August 15, 2014

Donald C. Cook Nuclear Plant Units 1 and 2
Response to a Request for Additional Information Regarding the License Amendment Request
Regarding Containment Divider Barrier Seal

RESPONSES TO REQUEST FOR ADDITIONAL INFORMATION REGARDING CONTAINMENT DIVIDER BARRIER SEAL LICENSE AMENDMENT REQUEST

15. BEAM FIXED AT BOTH ENDS—UNIFORMLY DISTRIBUTED LOADS

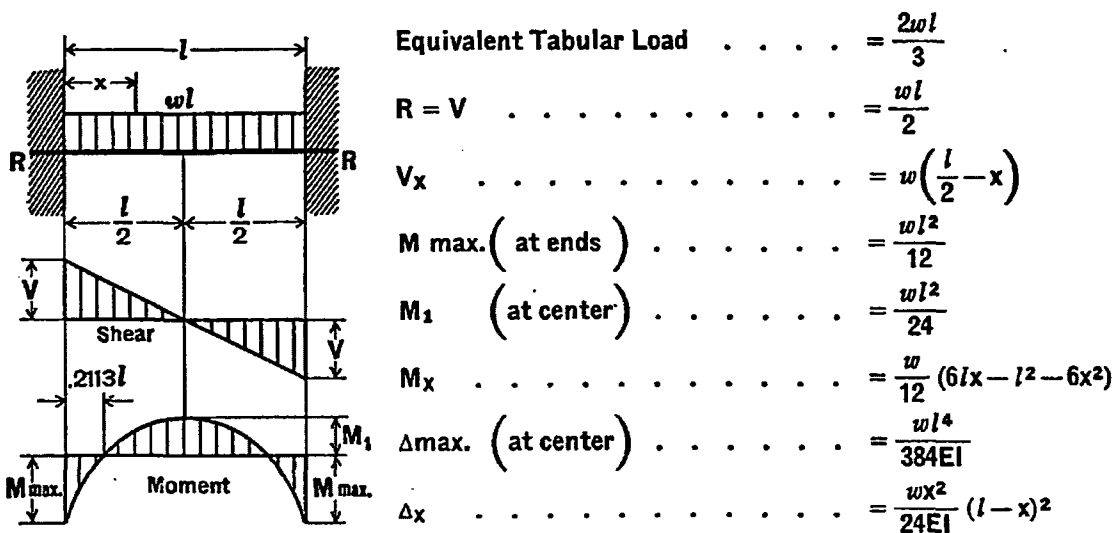
- a) What is the "simplified method" and what standard is this based on?*
- b) How will it be determined that this simplified method is more conservative than the American Institute of Steel Construction (AISC) Manual of Steel Construction, as referenced in SCVB RAI-3 response?*

The simplified method is also based on the AISC standard. An example is provided below to demonstrate the conservative nature of a simplified method as it uses the area of two triangles instead of computing the integral of the actual curved deflection shape. A simplified method would be more conservative as it would use a model that produces a larger deflection and area.

First example: For a model using a fixed beam, an exact structural analysis using an AISC formula is shown as follows:

As shown in the diagram #15 above, the deflection along any point of the beam is
 $\Delta_x = wx^2(L - x)^2 / 24EI$

To determine the assumed area of the divider barrier bypass from diagram #15, this requires computing the integral of this formula with respect to "x," and this is shown as

Consequently, for the length of the beam from $x = 0$ to L , the total bypass would be computed as $A_1 = wL^5 / 720EI$
